DRAFT MINUTES MHCC REGULATORY SUBCOMMITTEE MEETING

November 28, 2016

Action Item 8: Foundation Systems Requirements in Freezing Climates

Figure 2. Installation detail for Example#1 (FFF using crushed stone pad on subgrade)

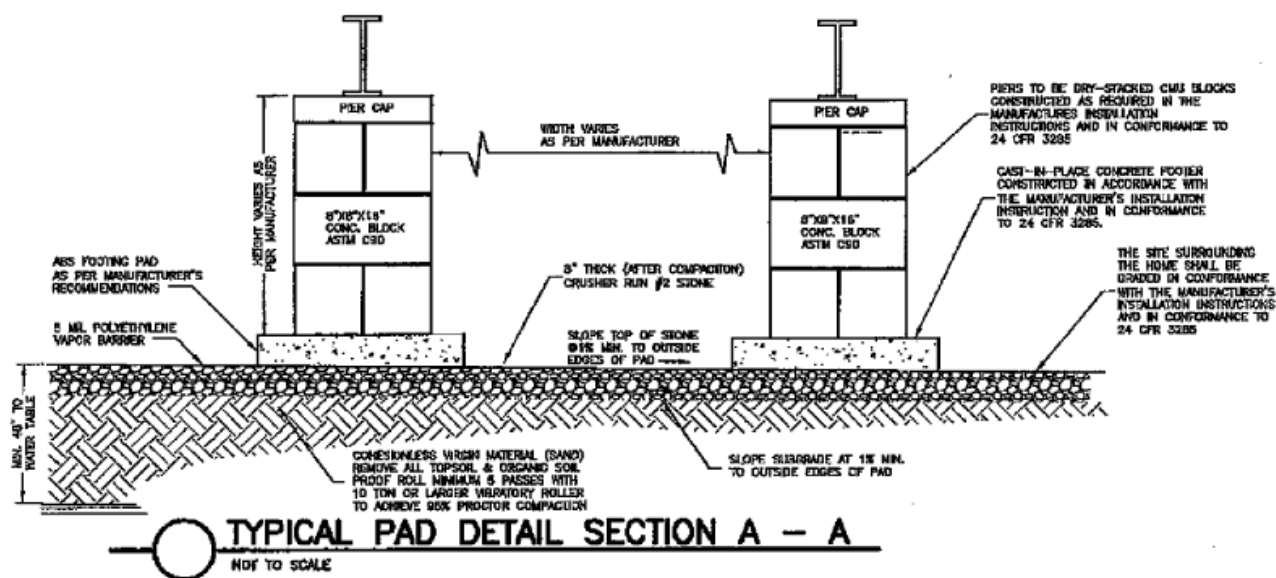
This design represents a reasonable application of the FFF technical requirements in accordance with Section 4.2 of the ASCE 32 standard. For example, it appropriately defines non-frost-susceptible material and requires it to be well-drained and to extend below the required frost depth. However, it places the burden on the local authorities for determining frost-susceptibility for each site application of the design, while at the same time requiring engineering verification (see "DESIGN NOTES" below). The reverse process is more appropriate (i.e., the engineer determines and the authority verifies). This may cause some unintended confusion as to roles and responsibilities which may be entirely missed by installers and those responsible for enforcement. Local authorities have an inspection and verification role, not a construction management or design decision-making role. To do otherwise creates a conflict of interest due to a lack of appropriate separation of roles and responsibilities.

This FFF design also includes a detail (Figure 2) which requires the subgrade to be cohesion less (sand) extending to a minimum depth of 48 inches and compacted with a 10 ton or larger vibratory roller. The water table is required to be at least 48 inches below finish grade together with surface grading required to meet the HUD code. Thus, the detail seems reasonably consistent with the technical intent of the design notes, despite confusion regarding important installation process considerations related to roles and responsibilities as mentioned above. However, the indicated “cohesion less (sand)” subgrade material could be moderately frost susceptible if it is a very fine sand (e.g., approaching silt-size particles). Thus, the Design Notes and plan detail should be clarified that the “6% of mass passing #200 sieve” also applies to the vaguely described cohesion-less sand material in the installation detail.

provide adequate protection against frost action. Furthermore, the 8" layer is located above what is intended to be a well-drained, non-frost-susceptible subgrade. In such a case, this sub-drainage will keep the 8" layer reasonably dry, particularly where located below the manufactured housing unit and protected from rainfall and runoff. Thus, the critical component of this design is assuring that the subgrade is indeed non-frost-susceptible and well-drained as called out on the plans consistent with the ASCE 32 standard.

Figure 3. FFF installation detail for Example #2 (FFF with piers directly on soil) based on SBRA/Hayman (2010) report.

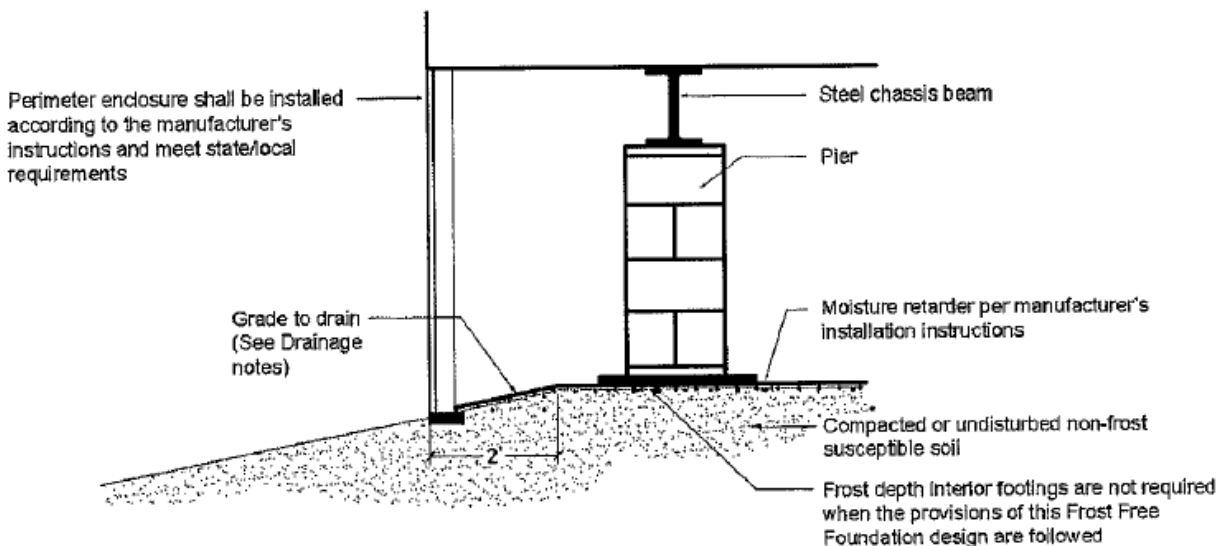
This design has a distinct difference from Example #1 and the ASCE 32 provisions: it relies exclusively on ensuring that “the soil beneath the manufactured home stays dry thereby preventing frost heave.” The report by SBRA/Hayman (2010) mistakenly claims that “Soil type is not relevant using the Frost Free Foundation design. Soil tests are not necessary.” For reasons discussed below, it is the opinion of this author, having served on the ASCE 32 committee and its task group on development of the non-frost-susceptible soil criteria, that these statements are not representative of the intent of the ASCE 32 standard or equivalent alternative procedures for ensuring the intent is met. (Refer to the earlier discussion on the meaning of key terms and clauses in the ASCE 32 standard.)

The first item neglects any means of establishing depth of ground water. It also fails to determine if the soil profile (at least to frost depth) is well drained. It also neglects the requirement that non-frost-susceptible soils be used in accordance with the HUD Code (24 CFR Part 3285.312(b)) and the ASCE 32 Standard. Reliance on surface drainage alone without site-specific soil drainage or water table analysis and soil particle size analysis is not consistent with accepted engineering practice for building foundations and also does not provide an equivalently reliable alternative to the methods and requirements specified in the ASCE 32 standard or the HUD Code.

For example, the installation detail based on the SBRA/Hayman (2010) report reveals the following (see Figure 3):

Figure 4. Installation detail for Example #3 (“Floating Slab” FFF)

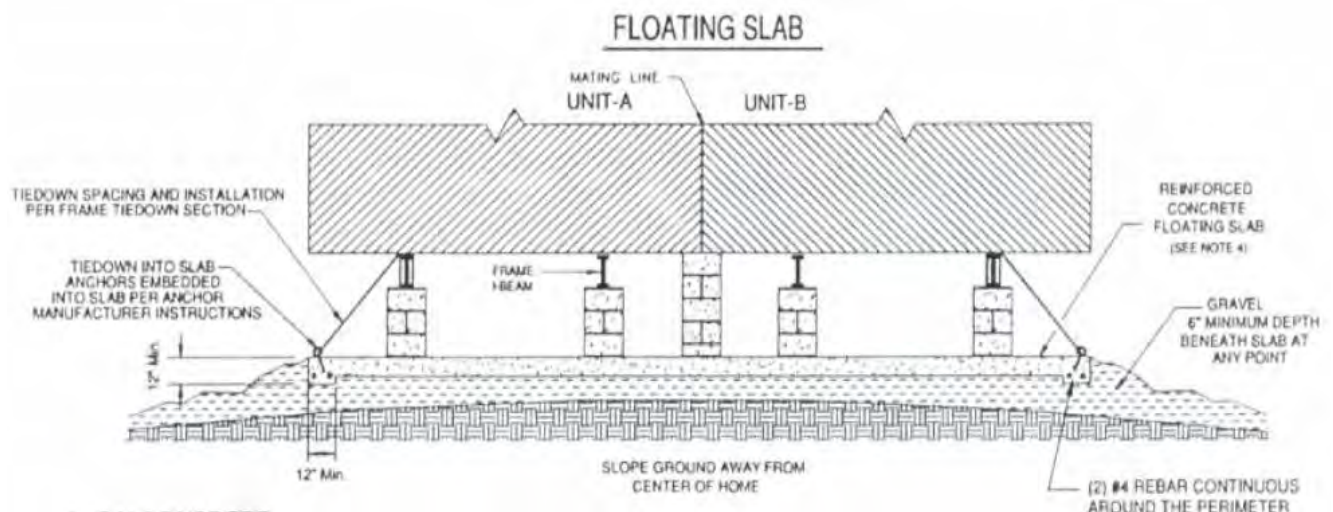
Relevant notes accompanying the installation detail shown in Figure 4 are as follows:

Figure 5. FFF installation detail for Example #4 (Monolithic Slab FFF)

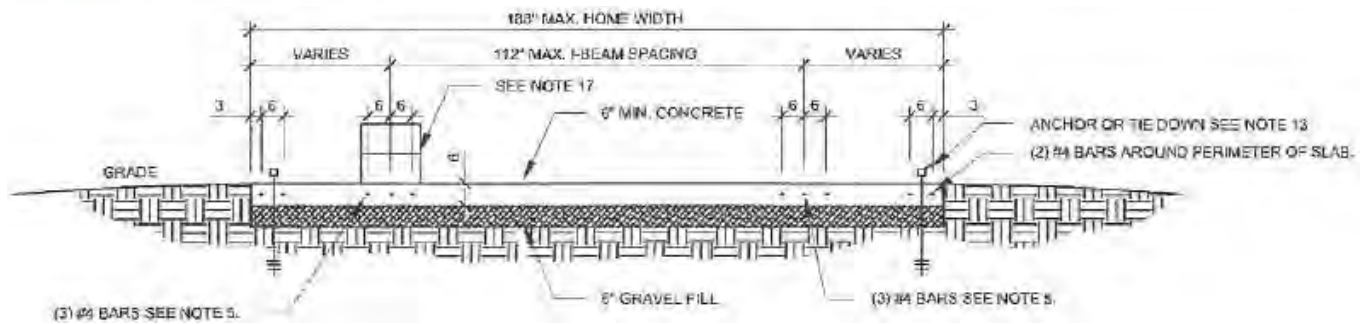
Relevant “GENERAL NOTES” associated with the above installation detail are as follows:
